TC4 Optional Arm Mount Supplement

10.21.04

31068 - TC4 Aluminum Rear Arm Mount, X-2.5

31069 - TC4 Aluminum Rear Arm Mount, X-2.0

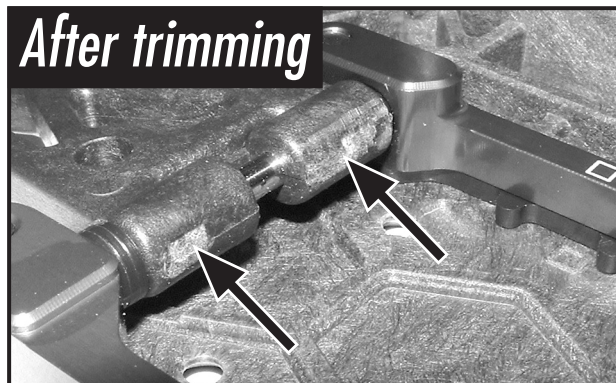
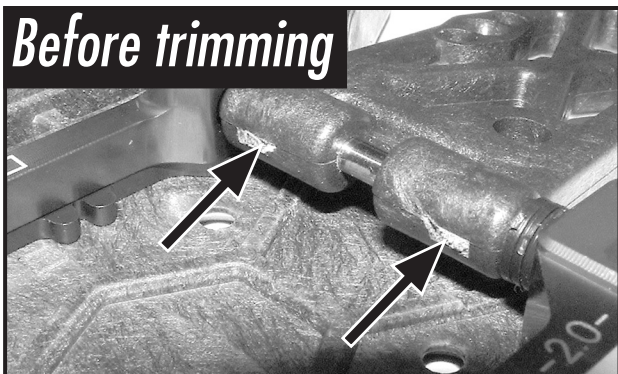
In order to obtain the optimized geometry, there is a very tight tolerance between the arms and the rear transmission case on your TC4. They are especially close when using the 31068 and 31069 (X-2.5, X-2.0 blocks). In order to prevent the suspension from binding, it is recommend to trim the rear arms as shown. **DO NOT** trim away more material as this will weaken the suspension arm.
